Liquid Stone Concrete - CSP

Site Plan (22-165)

Background:

➤ IH-35 Building Design (a)

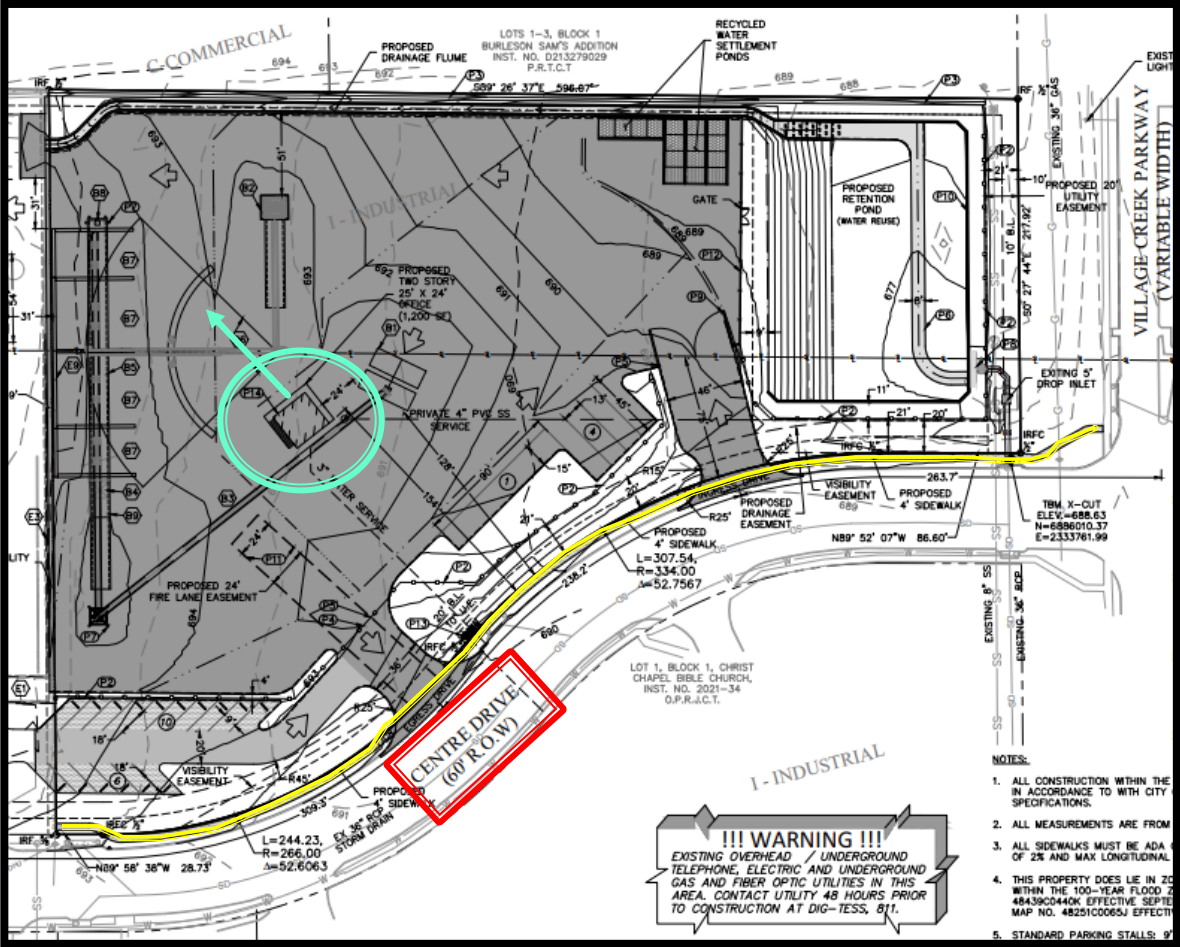
<u>Required:</u>	One primary entryway shall face the principal street and connect directly to a sidewalk along the principal street.
<u>Provided:</u>	Primary entryway will not face towards nor connect to principal street. Sidewalk will be constructed along principal street.
<u>Justification:</u>	Primary use of the site is industrial. The main building / site are not intended for public use and will be screened accordingly

➤ IH-35 Building Design (c)

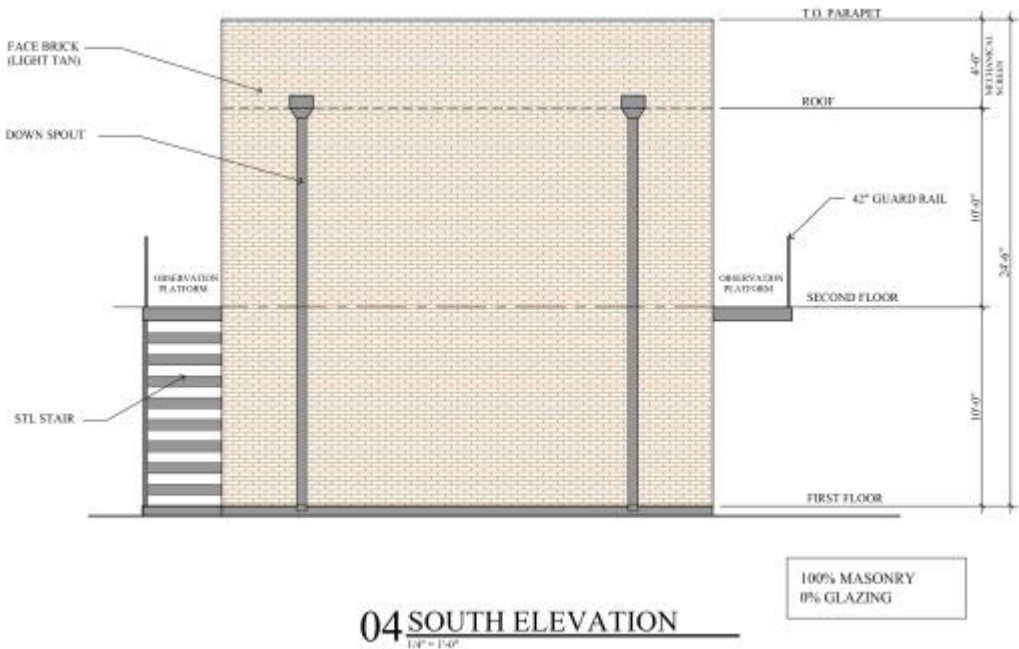
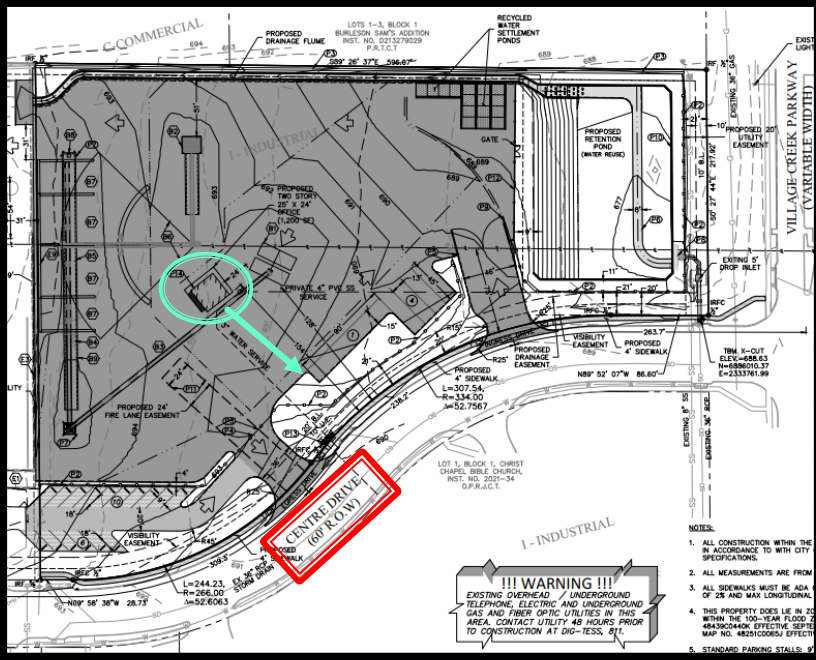
<u>Required:</u>	On the building façade facing the principal street, at least 35 percent of the wall area on the first floor shall consist of windows or similar glazing
<u>Provided:</u>	South façade facing the principal street does not provide any glazing. <ul style="list-style-type: none">• North elevation: 15%• East elevation: 13%
<u>Justification:</u>	Building is designed as a control area for the plant with specific views to the equipment and trucks. Windows are intended for observation of strategic operations and safety requirements.

➤ IH-35 Building Design (d)

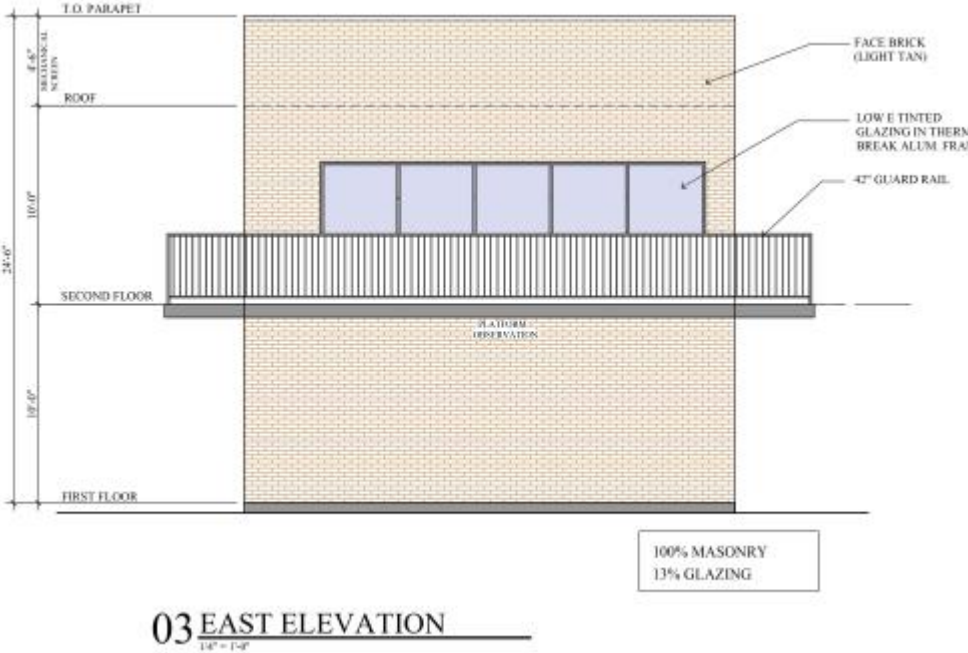
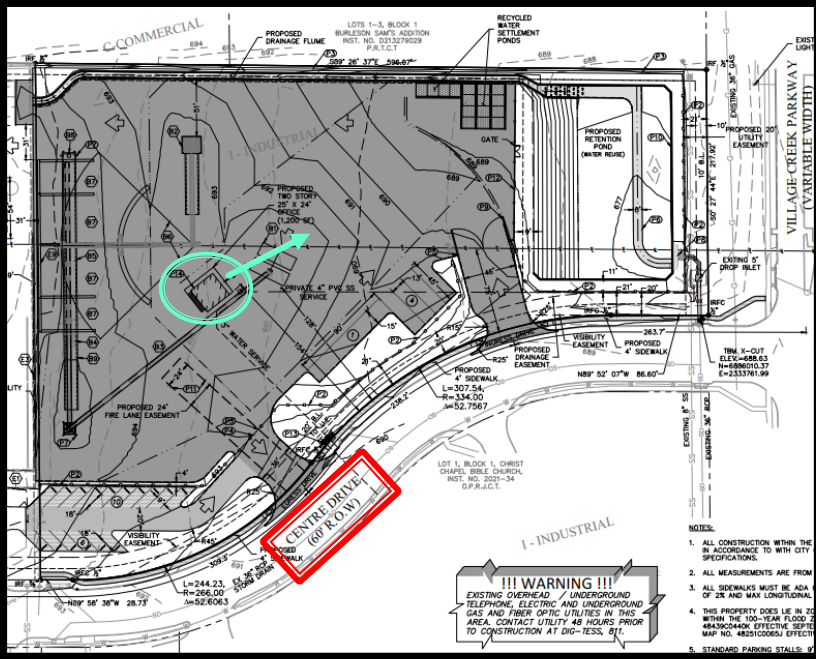
<u>Required:</u>	On all other publicly visible façades, at least 20 percent of the wall area shall consist of windows or similar glazing.
<u>Provided:</u>	Other publically visible façade to the east provides 13% glazing <ul style="list-style-type: none">North elevation: 15%
<u>Justification:</u>	Building is designed as a control area for the plant with specific views to the equipment and trucks. Windows are intended for observation of strategic operations and safety requirements.

➤ IH-35 Building Design (g)

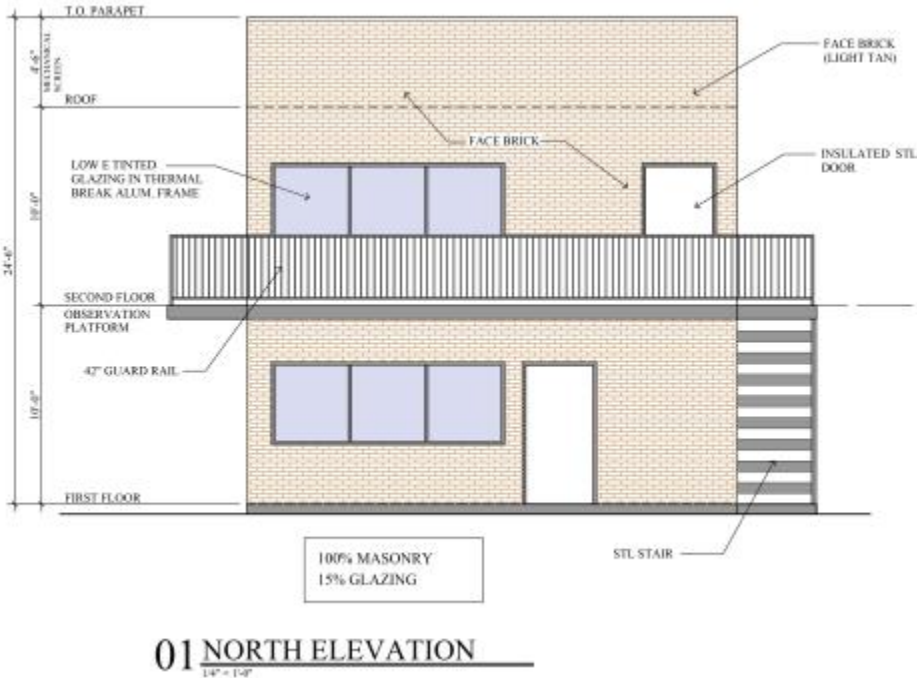
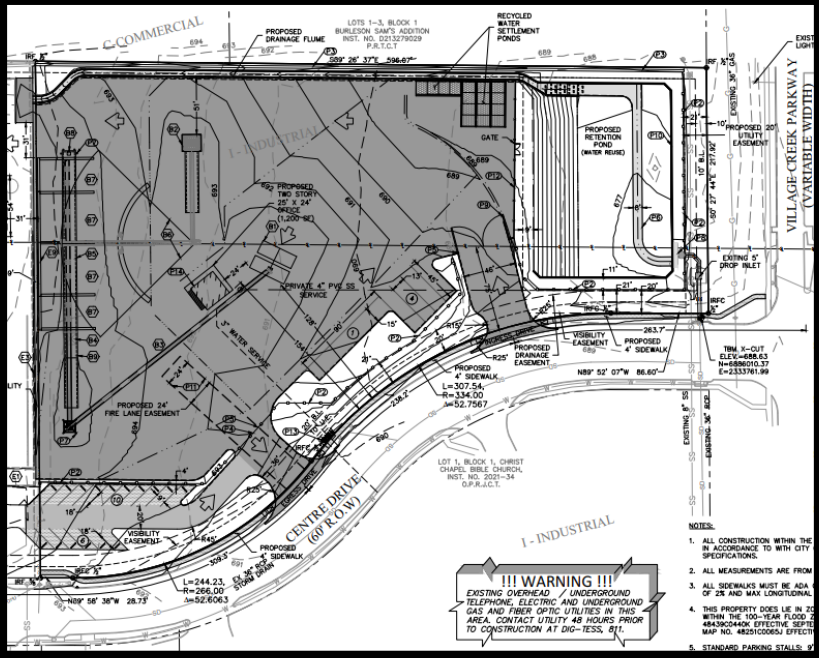
<u>Required:</u>	Buildings shall provide a minimum of three building design elements as provided in the IH-35 Building Design Section.
<u>Provided:</u>	None of the building design element options are being applied to the proposed building.
<u>Justification:</u>	The design standards are not intended to be for a safe and secure industrial facility. The building/site is not intended for public use, therefore no additional building designs or architectural elements are being installed.

- IH-35 Landscaping (h)

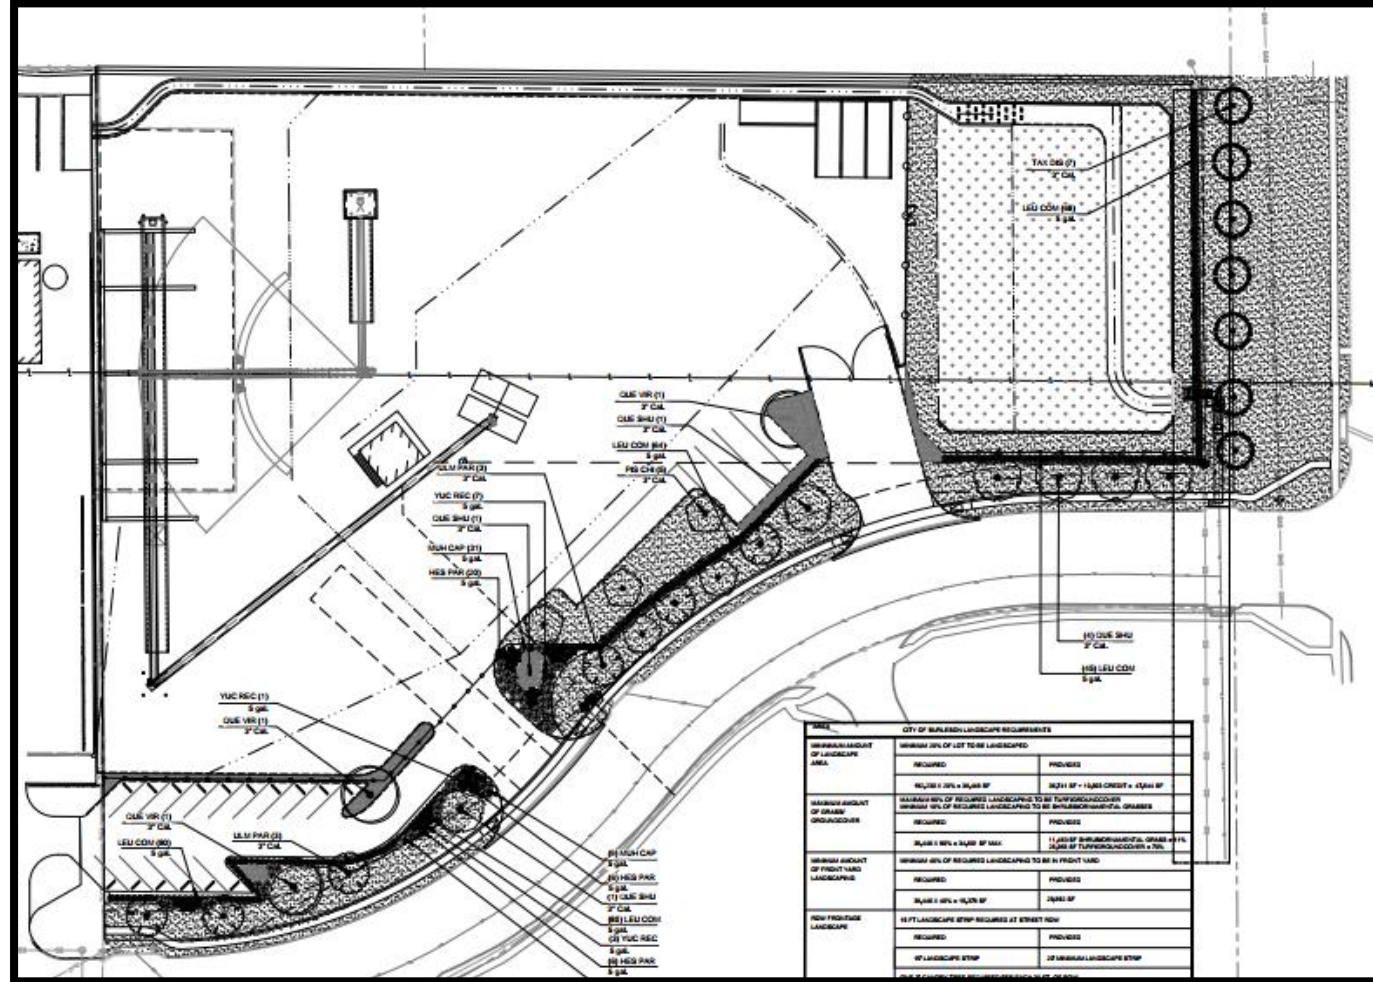
<u>Required:</u>	Developments shall provide at least 25 percent of the required landscaping area as natural open
<u>Provided:</u>	Proposing to provide 14.3% open space in lieu of the required 25%.
<u>Justification:</u>	Due to detention requirements, equipment circulation and safety, the public open space cannot be satisfied entirely.

➤ IH-35 Screening (a)

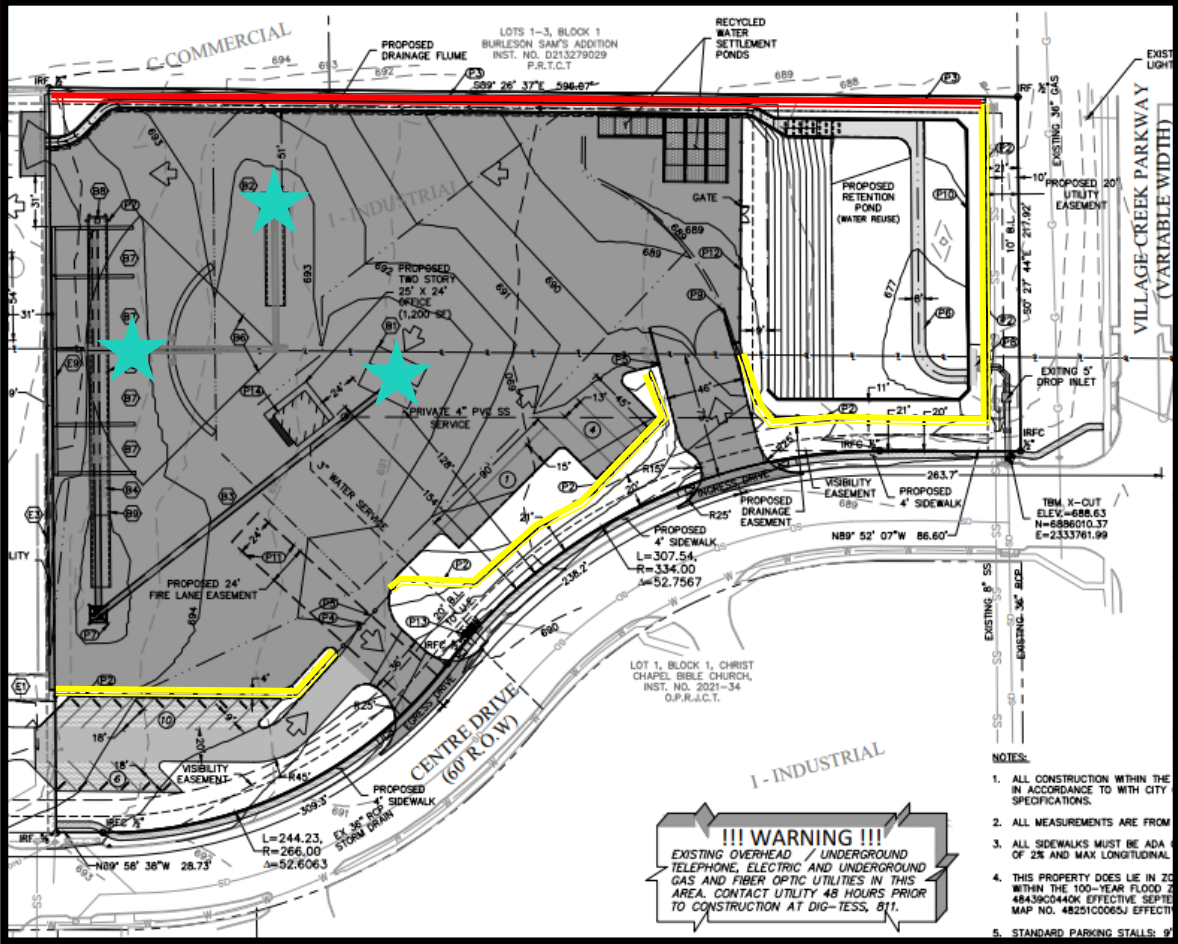
Required:	Mechanical equipment and other support elements for buildings shall be screened from view of any person standing on the property line.
Provided:	<ul style="list-style-type: none">8' masonry wall along the south and east (principal) sides of the property12' masonry wall along the north (rear) property boundary.
Justification:	Screening the equipment entirely cannot be achieved due to the height of batching equipment = 42 – 85 feet

Per the Texas Commission on Environmental Quality (TCEQ):

- 12 foot screening wall; or
- 50 foot buffer from all equipment shall be provided.

The northern property line is the only property line that does not meet the 50' buffer requirement so a 12' masonry fence was proposed.
